Project Name: Delray Chevrolet

Project Location: 2605 South Federal Highway

SITE PLAN REVIEW AND APPEARANCE BOARD STAFF REPORT

Application Type: Class III Site Plan Modification,
Landscape Plan, Architectural Elevations – Delray
Chevrolet

SHEET C-7

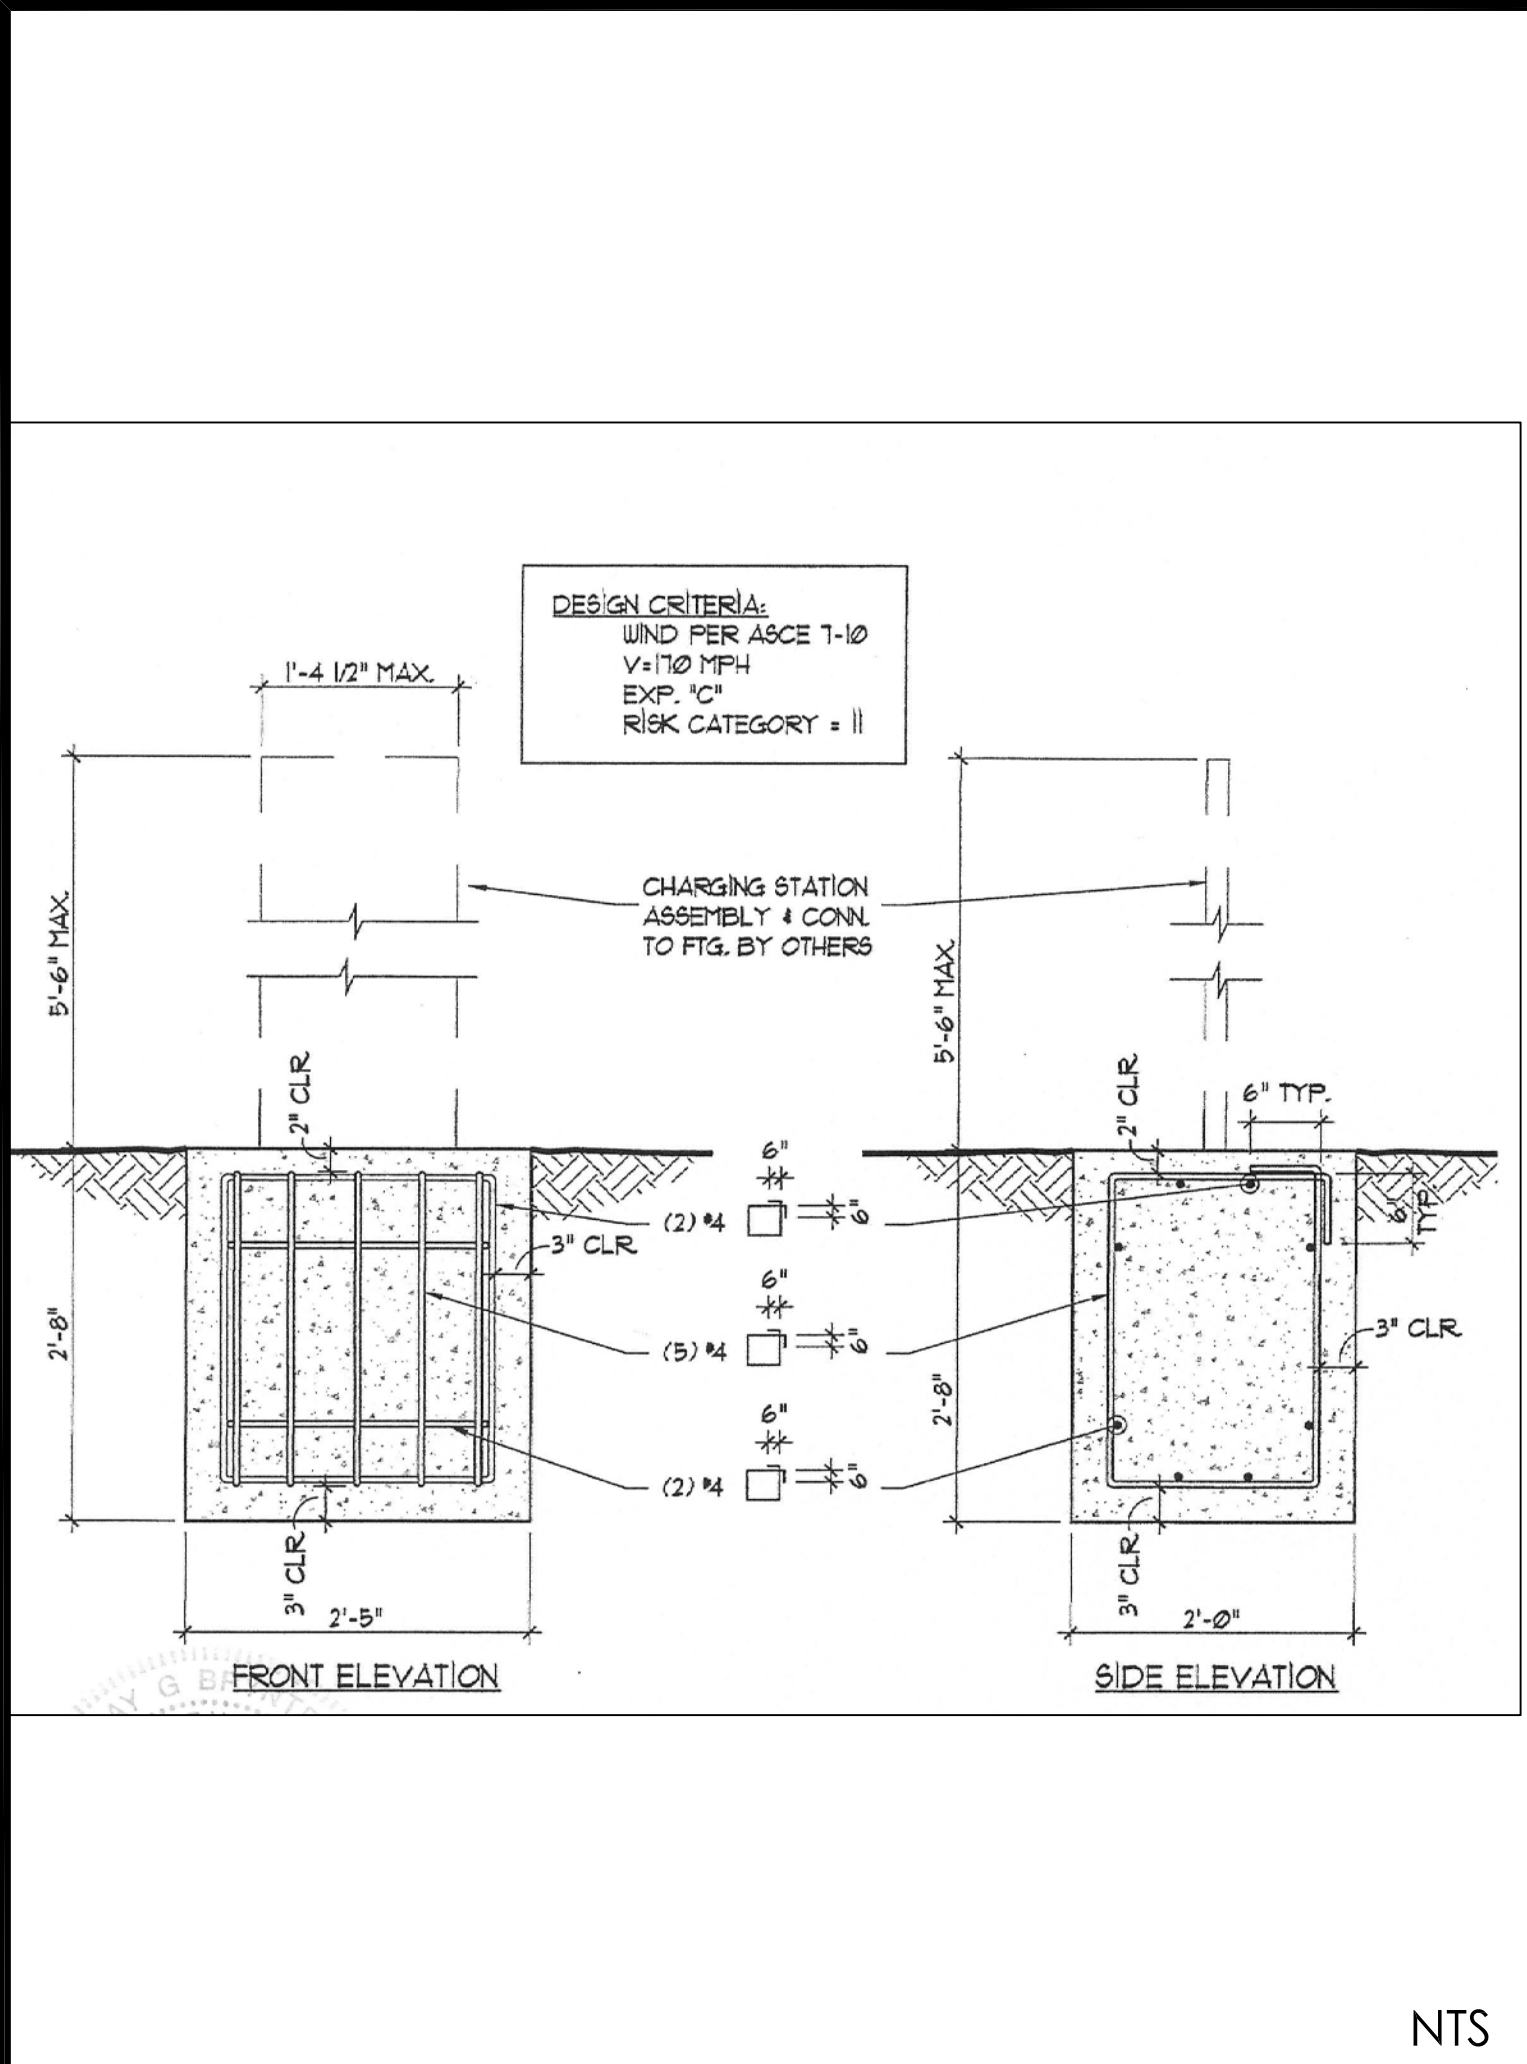
The parking designation chart shown on Sheet C-7 provides a breakdown of parking uses and size of spaces provided. Display parking is located parallel to South Federal Highway. Two vehicle charging stations have been provided within the customer parking area on the southwest corner of the site. Bullpen parking has been screened per LDR requirements.

SHEET L-1 3

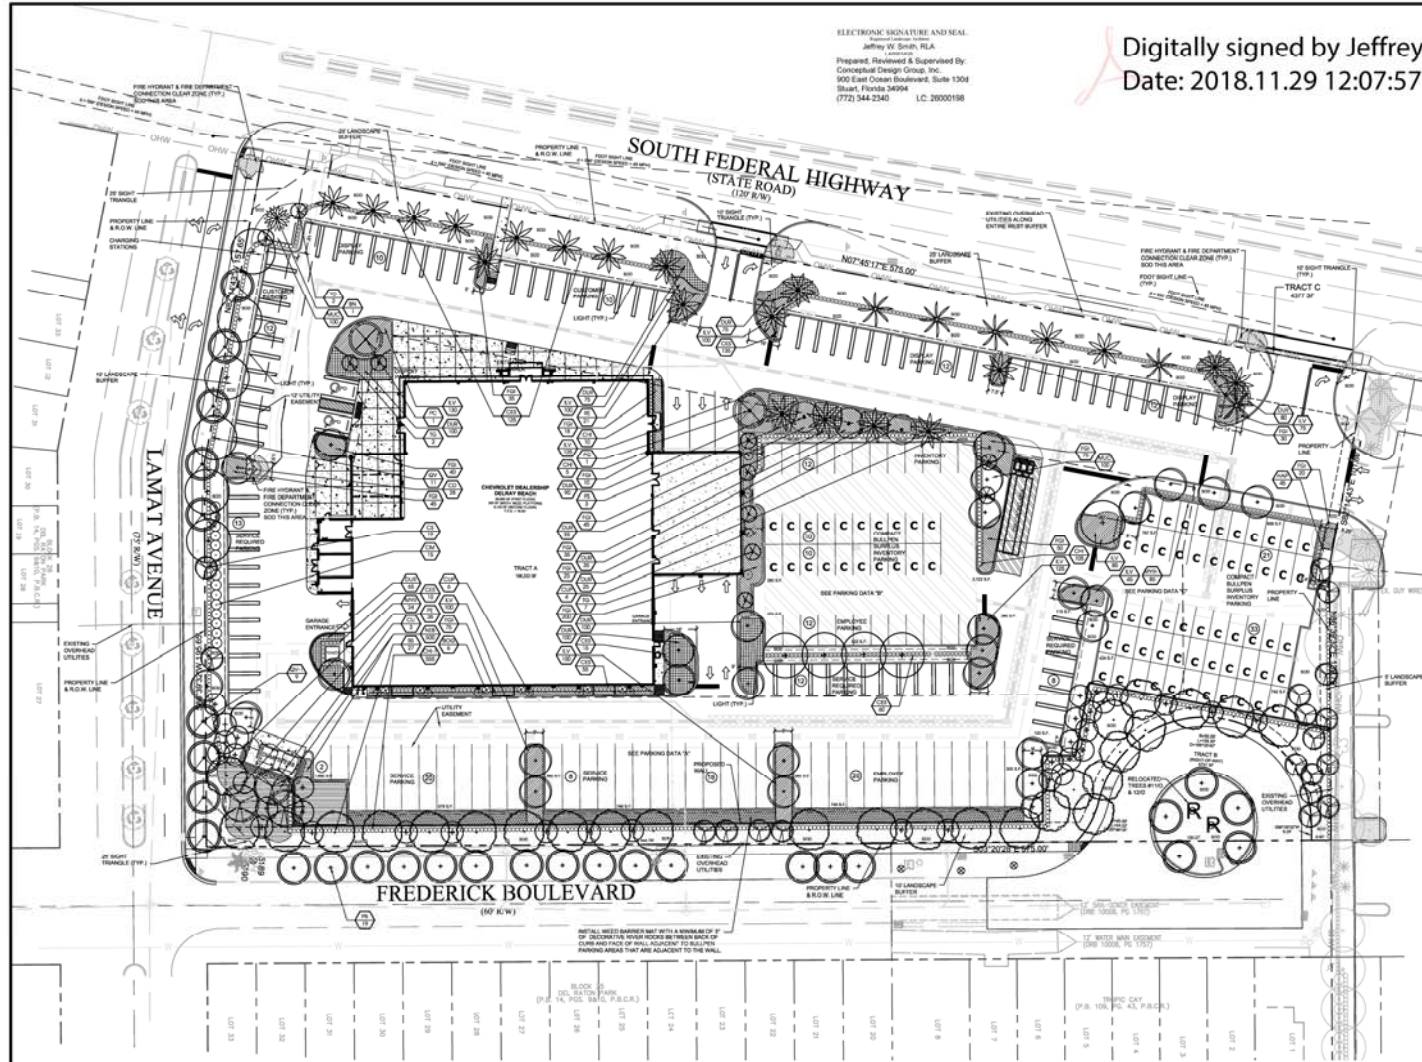
Within the AC zoning district, outdoor display of vehicles must be separated from all adjacent streets by a hedge or berm at least three feet high and trees planted at least 40 feet on center. The depth of landscape strip between the car display and the ultimate right-of-way shall be 25-feet. Bullpen parking does not require landscaping islands and strips. Ten percent interior landscaping requirement shall be met by transferring the required landscaping to the perimeter of the site or bullpen area. Bullpen island

calculations have been provided on Sheet L-1. The proposed design meets the requirements.
